Addendum 128– UN Regulation No. 129

Revision 2 – Amendment 1

Supplement 1 to the 02 series of amendments – Date of entry into force: 10 February 2018

Uniform provisions concerning the approval of Enhanced Child Restraint Systems used on board of motor vehicles (ECRS)

Figure 1

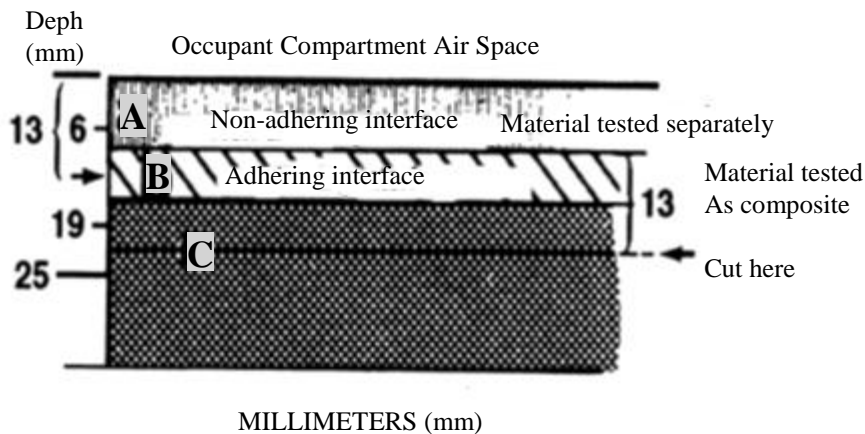
Insert a new Annex 24, to read:

1. Definitions
"Occupant compartment air space" means the space within the occupant compartment that normally contains refreshable air.
2. Material selection (see Figure 1 below)
 - 2.1. Any portion of a single or composite material which is within 13 mm of the occupant compartment air space shall meet the requirements in paragraph 6.1.6.
 - 2.1.1. Any material that does not adhere to other material(s) at every point of contact shall meet the requirements of paragraph 6.1.6. when tested separately
 - 2.1.2. Any material that adheres to other materials at every point of contact shall meet the requirements of paragraph 6.1.6. when tested as a composite with the other material(s).

Material A has a non-adhering interface with material B and is tested separately.

Part of material B is within 13 mm of the occupant compartment air space, and materials B and C adhere at every point of contact; therefore, B and C are tested as a composite.

The cut is in material C as shown in Figure 1, to make a specimen 13 mm thick.

Figure 2
All dimensions in millimeters (mm)

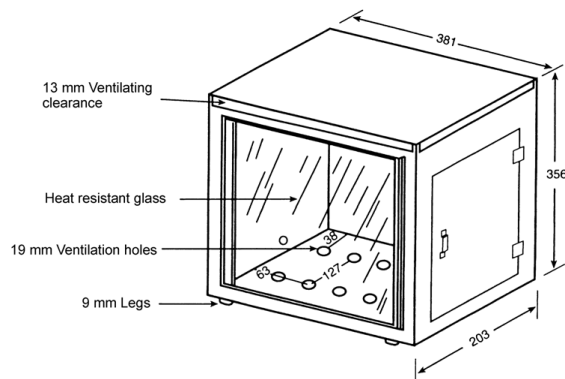
3. Test procedure
 - 3.1. The test is conducted in a metal cabinet for protecting the test specimens from drafts. The interior of the cabinet is 381 mm long, 203 mm deep, and 356 mm high. It has a glass observation window in the front, a closable opening to permit insertion of the specimen holder, and a hole to accommodate tubing for a gas burner. For ventilation, it has a 13 mm clearance space around the top of the cabinet, ten holes in the base of the cabinet, each hole 19 mm in diameter and legs to elevate the bottom of the cabinet by 10 mm, all located as shown in Figure 2.
 - 3.2. Prior to testing, each specimen is conditioned for 24 hours at a temperature of 21° C, and a relative humidity of 50 per cent, and the test is conducted under those ambient conditions.
 - 3.3. The test specimen is inserted between two matching U-shaped frames of metal stock 25 mm wide and 10 mm high.
